<b>Title-Sujet</b>		
Construction-Renovation-Air Hangar Door Upgrade, Prince Albert, Saskatchewan		
<b>Solicitation No. – No. de l'invitation</b>	<b>Amend. – Modif.</b>	<b>Date</b>
201702350	No. : 3	August 22nd, 2016
<b>Client Reference No. - No. de Référence du Client</b>		
201702350		
<b>GETS Reference No. – No de Référence du SEAG</b>		
201702350		
<b>Solicitation Closes – L'invitation prend fin</b>		
<b>at - à 2 :00 pm ET</b>		
<b>on - le August 30th, 2016</b>		
<b>F.O.B. - F.A.B.</b>		
Destination		
<b>Address Enquiries to: - Adresser toute questions à :</b>		
Penny Maillard – Senior Contracting Officer		
<a href="mailto:penny.maillard@rcmp-grc.gc.ca">penny.maillard@rcmp-grc.gc.ca</a>		
<b>Telephone No. - No de téléphone</b>	<b>Fax:</b>	
613-843-5518	613-825-0082	
<b>Destination of Goods - Destinations des biens:</b>		
<b>See Herein</b>		
<b>Instructions : See Herein / Voir aux présentes</b>		
<b>Delivery Required – Livraison exigée:</b>

Amendment #3 of Solicitation 201702350 has been issued to respond to **Questions and Answers – Part 1**, and **Request for Alternatives Products and/or Materials – Part 2** and to issue **Addendum #1** for this requirement.

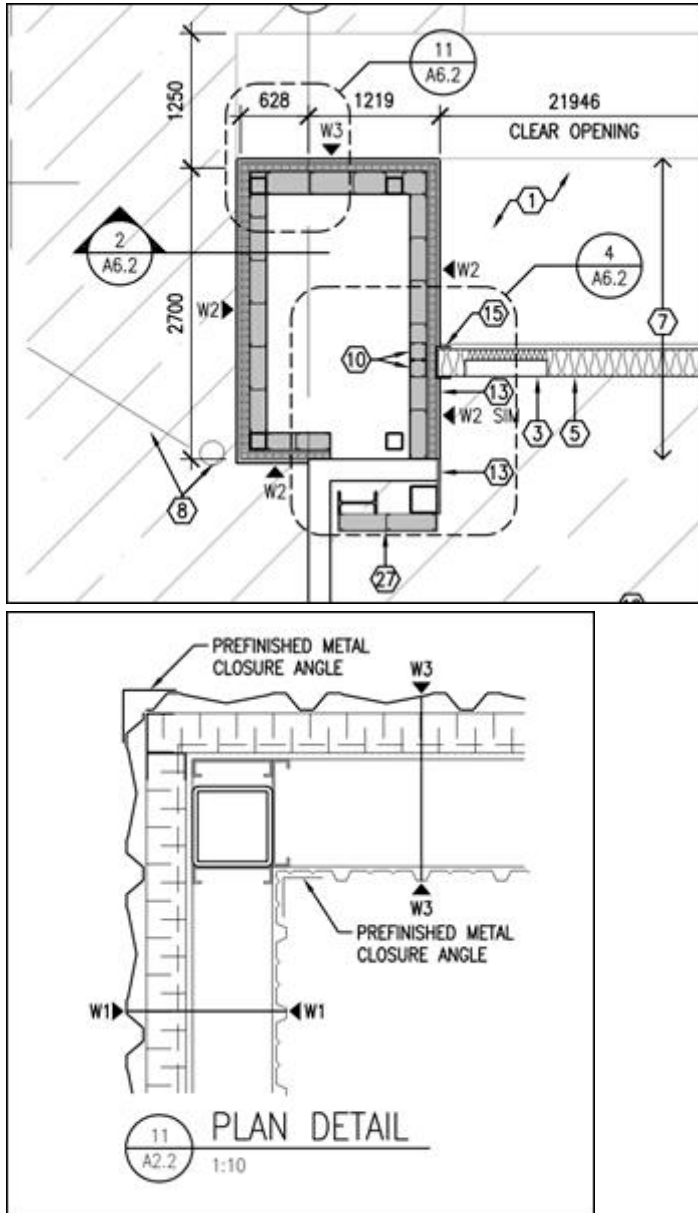
**Q11** Spec section for Preformed Metal Siding (07 46 13) 2.4.1.4 states that the liner panels must act as a vapor barrier. Wall Type W1, W2 & W3 call for AVB membrane (Blueskin SA as per spec section 07 27 00 - 2.3.1.1) on exterior side of sheathing. Double vapor barriers will cause condensation within wall system If liner panel is to be vapor barrier, should exterior membrane be vapor permeable aka VP 100 (spec section 2.4.1.1)? If liner panel is not to be sealed as a vapor barrier, Blueskin SA will work. Please advise what should we do.

**A11** See Addendum # 1, **Article A-1-4 and Article A-1-6, Points #14 & #15**
